WRITTEN STATEMENTS

9 February 2021

**Planning and Amenity Delegated
Committee Meeting**

Tree 8

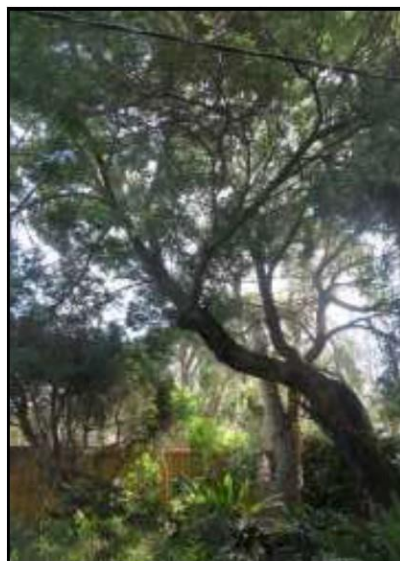
- **Tree 8** has been assessed as poor structure and fair health from our consulting arborist. Council is of a different opinion and have recommended tree 8 be retained. We kindly request this recommendation be reviewed as the tree clearly appears to be in poor health and could propose a risk to property damage and person, it's currently been supported with a stake.

Fig 2 (Overlooking shown in Blue and Green):

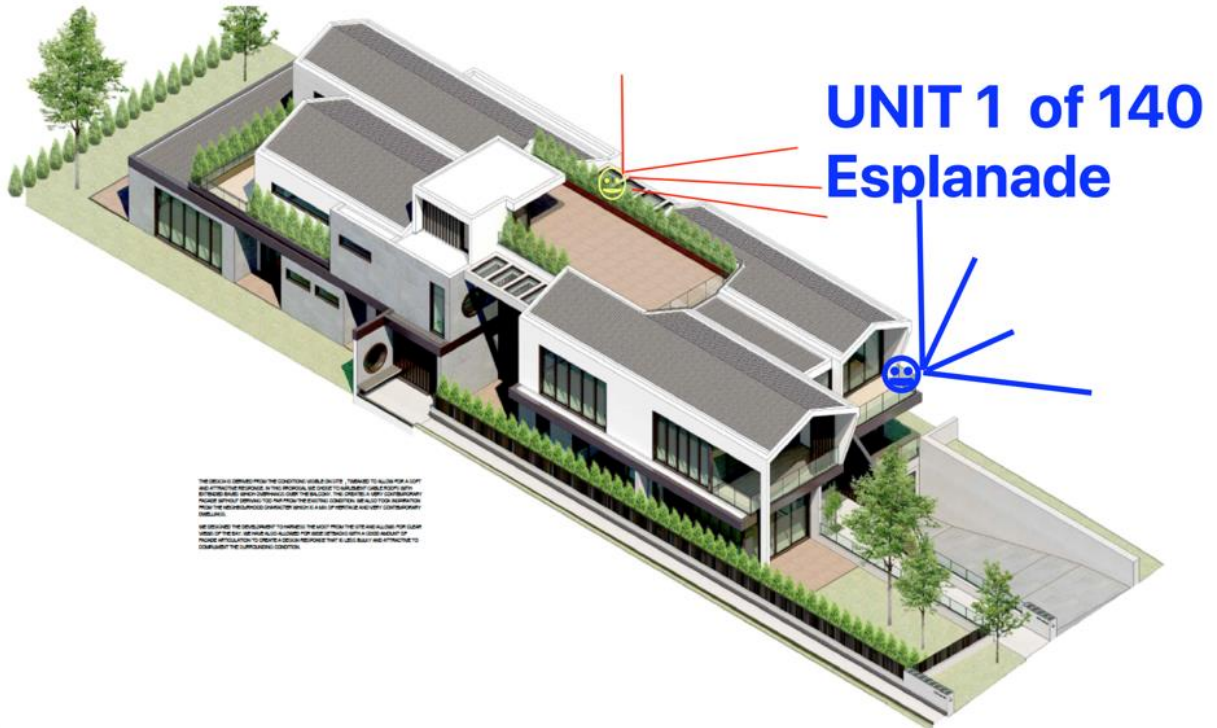
There are direct views from the south west elevation into the private open space and sensitive habitable rooms of 140 Esplanade. The proposal needs to comply with the B22 Standard requirements of “permanently fixed external screens” or “fixed, obscure glazing” to at least 1.7 metres above floor level. See Images below (Fig 2 and 3), with specific reference to:

1. There needs to be a 1.7m screen on the south west facing edge of the D2 Main Bed Balcony facing 140 Esplanade
2. Windows in the center of the first level need to be fixed, obscure glazing to at least 1.7 metres above floor level specifically in LD, Bed 2 and the corridor in the middle of D2 facing unit 1 of 140 Esplanade

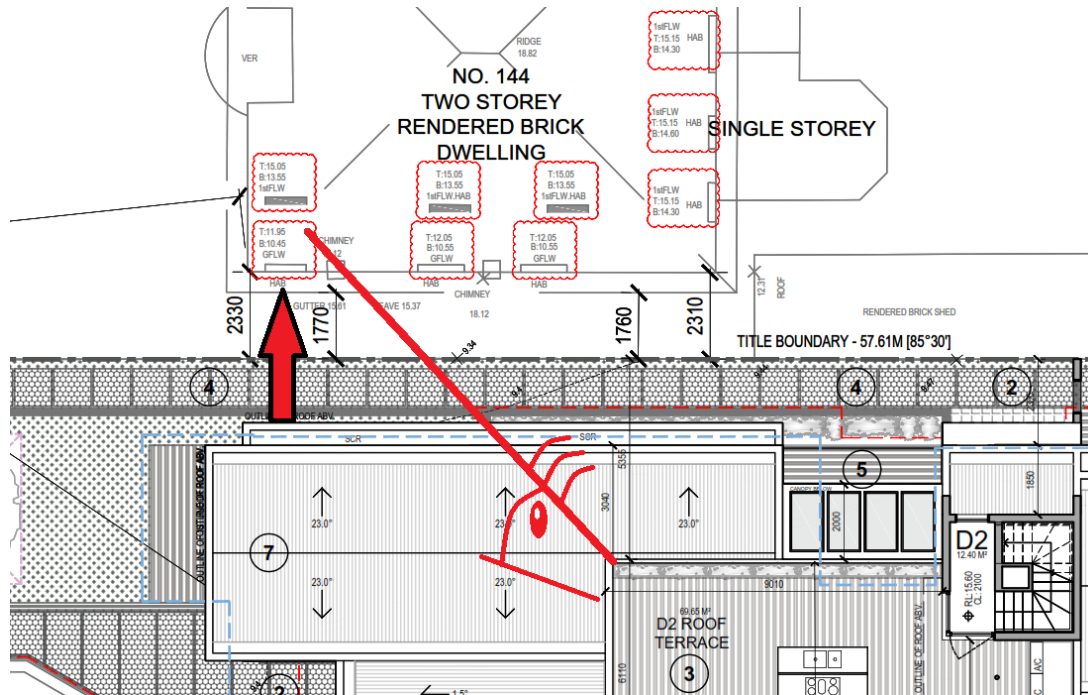
The visual bulk of the proposed development is unreasonable (even greater than the original design that was presented at the VCAT hearing) and does not fit with the surrounding neighbourhood character. I respectfully ask Council representatives why they would endorse this design response given VCAT's paragraph 7 statements above.

PLAN VIEW

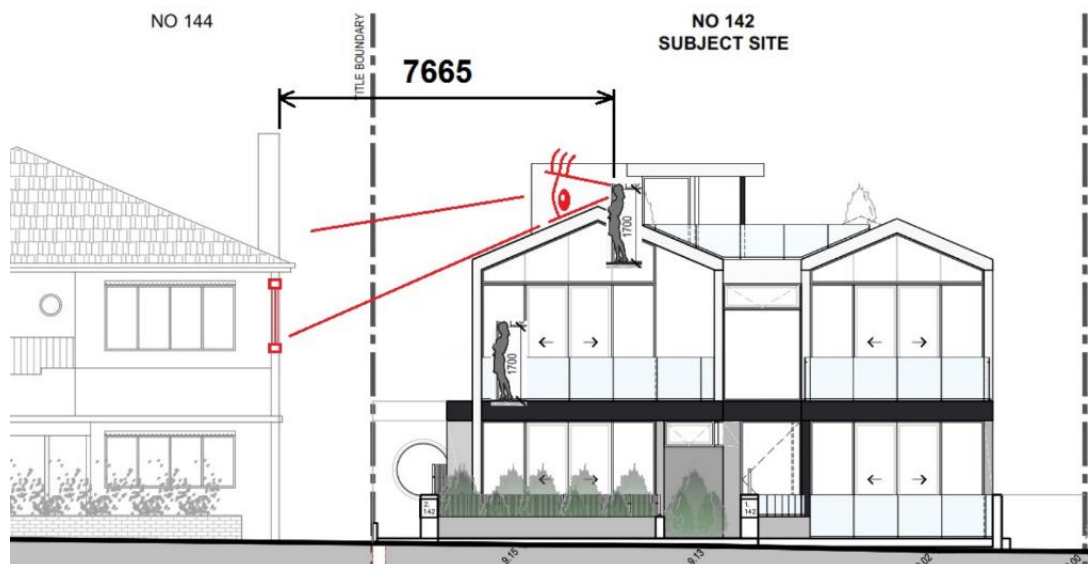
Overlooking objective – the roof top front-facing balcony has direct views into my bedroom window and is within 45 degrees of the perimeter of the north-west corner of the roof deck and within a horizontal distance of 9 metres of 144 Esplanade bedroom windows. Even if it is claimed to be more than a 9metre distance, councillors must understand the unreasonable visual intrusion that this design presents. Extending the 1700mm visual barrier along the northern roof ridge line would prevent any unsolicited visual intrusion.

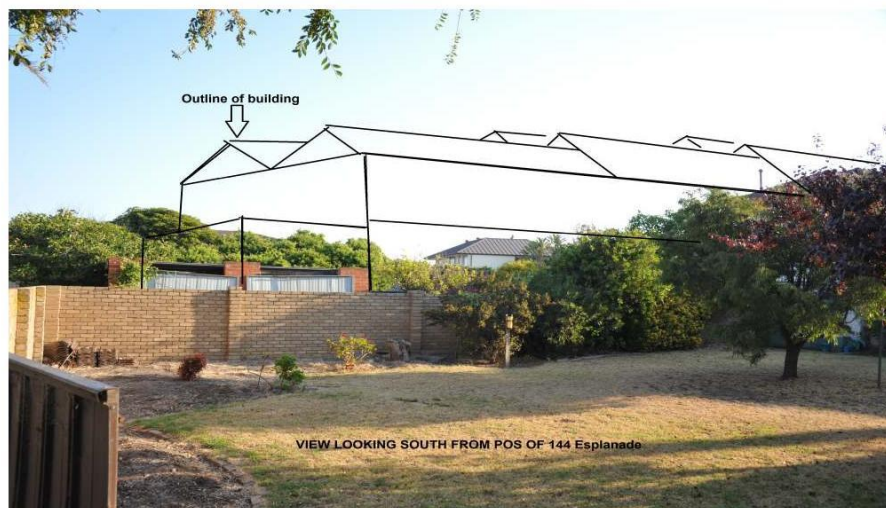
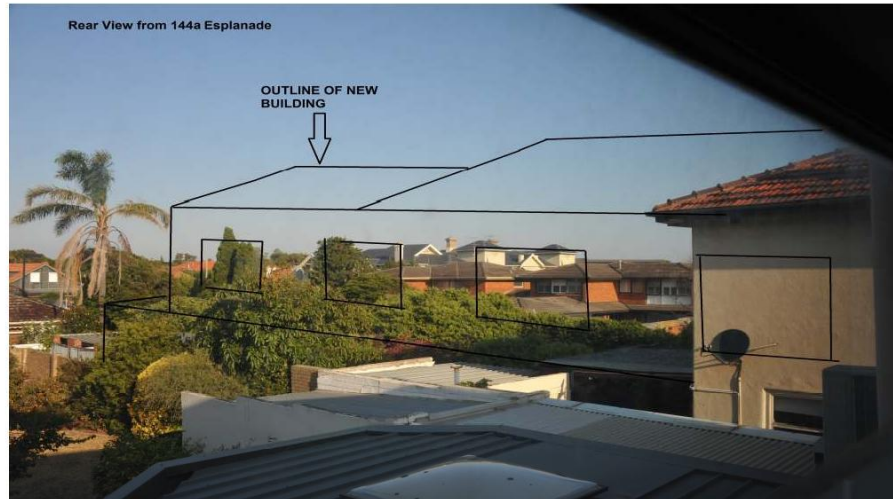
Councilors to clarify with the planning officer(s) how approval was given to the design response with a bigger wider proposed building footprint than the previous design, which presents less opportunity for landscaping to soften the sides of the 2 storey exterior, due to reduced side setbacks as per the previous design set aside.

Councilors to note the smaller design (in blue above) was set aside by VCAT for the following recorded reasons in the VCAT 624 ORDER;
